SOUTH SAN FRANCISCO FERRY TERMINAL PIER STRUCTURES

ADDENDUM NO. 2

December 9, 2009

Pre-Proposal Meeting attendees and notes
Q&As
Modification to Pier Doors
Modification of Liquidated Damages Paragraph
Changes the date and time that technical proposals are due
Remove redundant specification section on coatings
Remove specification section on the steel gangway

PROJECT
SOUTH SAN FRANCISCO FERRY TERMINAL
SHEET
**PIER INTERMEDIATE PARTITION
ELEVATIONS AT GRIDLINE P10**

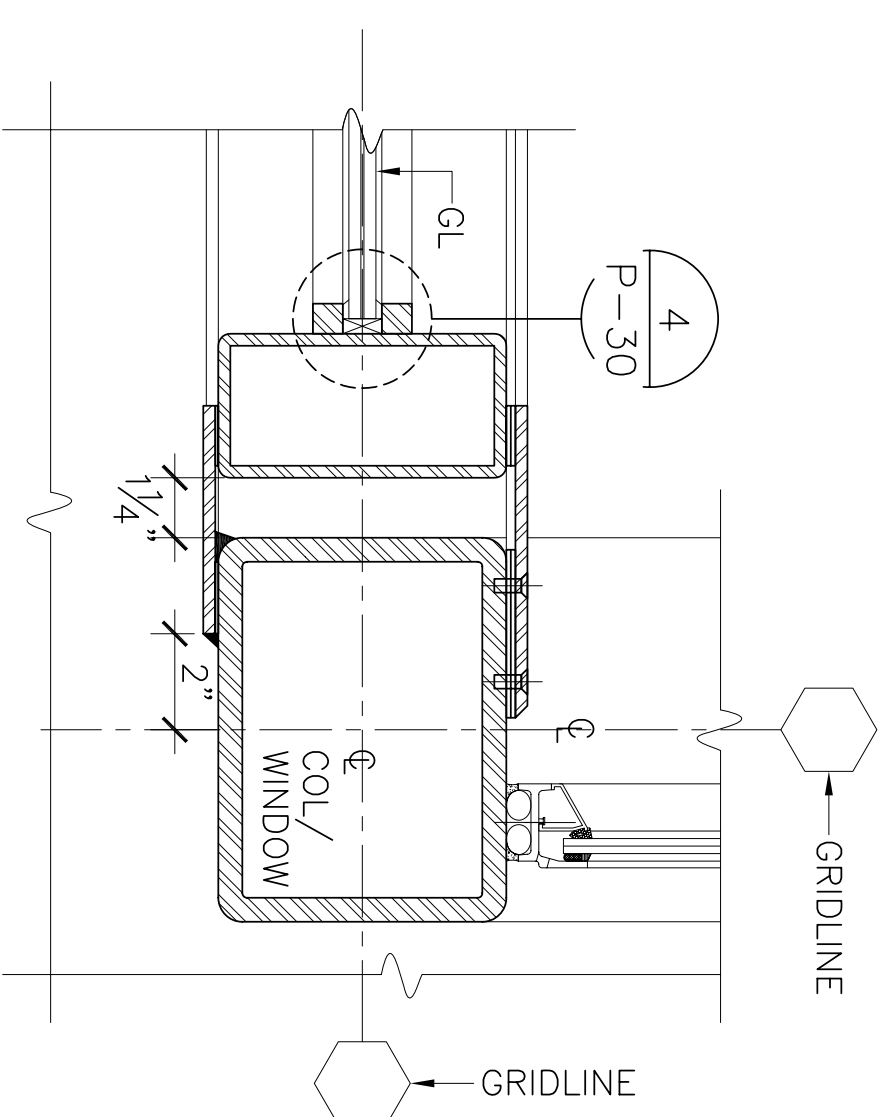
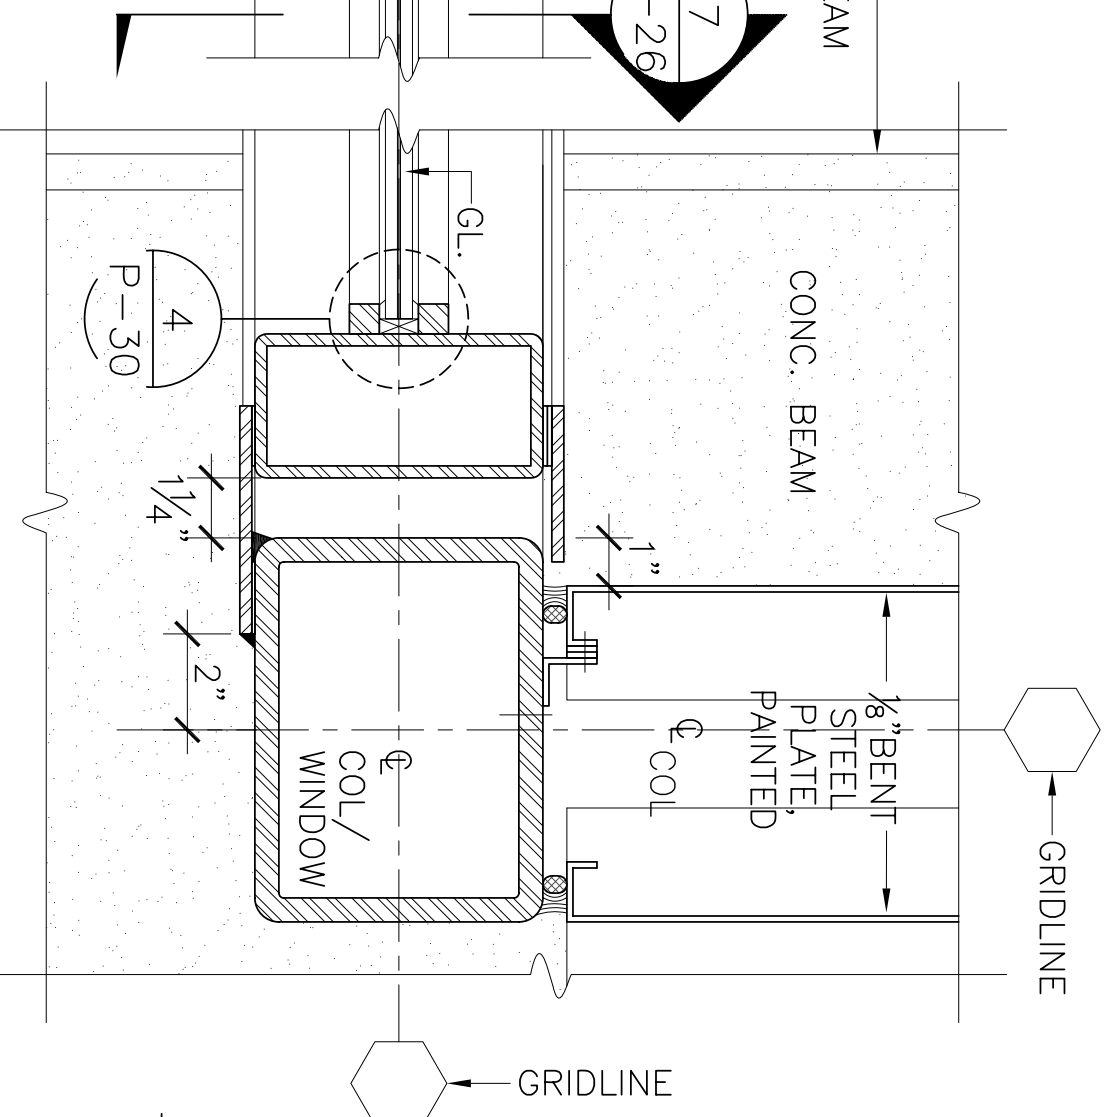
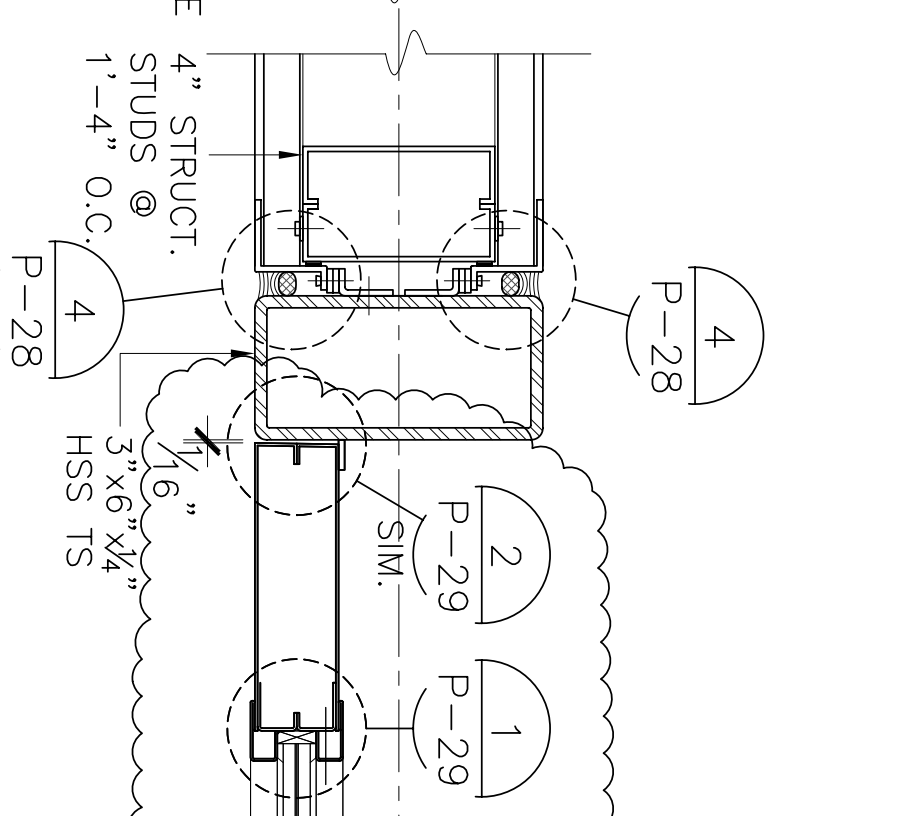
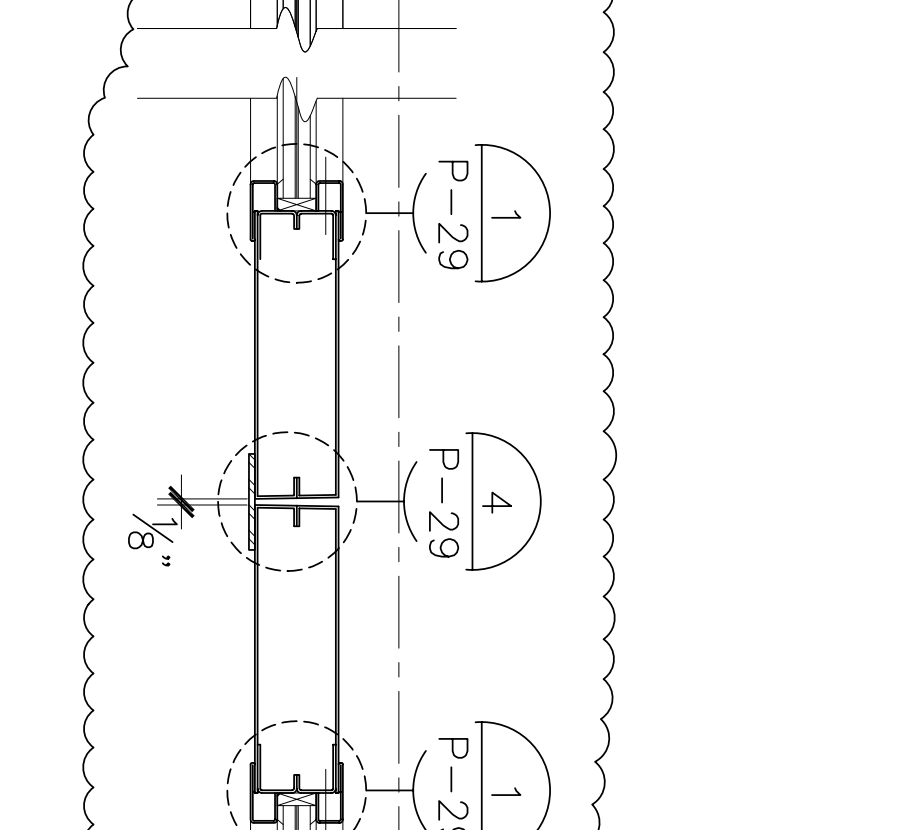
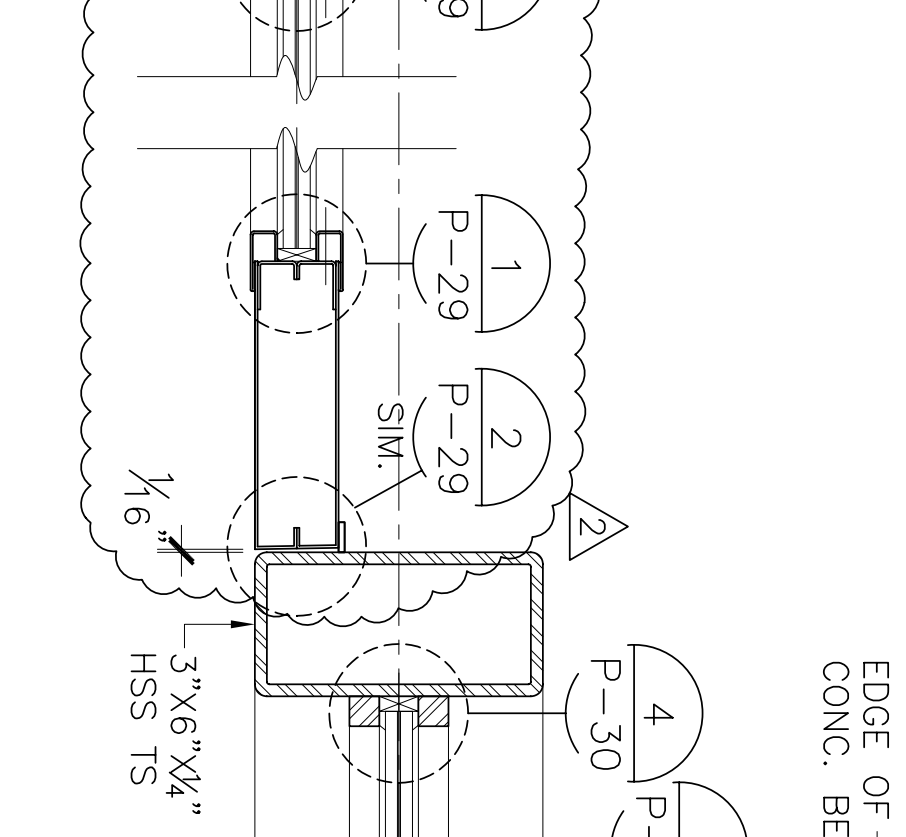
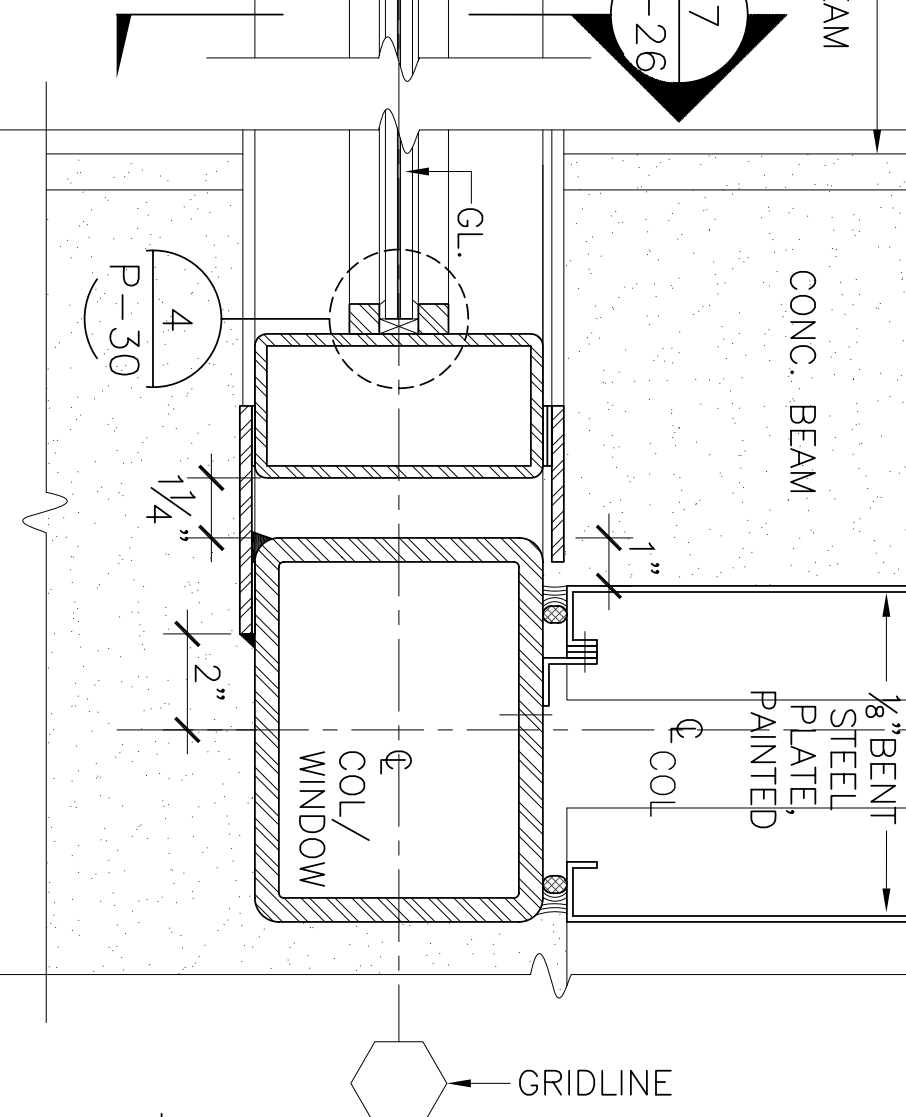
- Q97: Center Hung Doors cannot Swing 180 Degrees as shown, as they will be stopped by the jamb. We have been able to Swing Doors 180 Degrees by using Horton's 4100 Power Swing Operator on the pull side of the Doors and using a Custom Arm arrangement. Please clarify.

- A97: Doors have been relocated to be flush with HSS TS to allow 180° swing. See change specification and drawing changes attached to Addendum 2 for the Package 2 RFP.
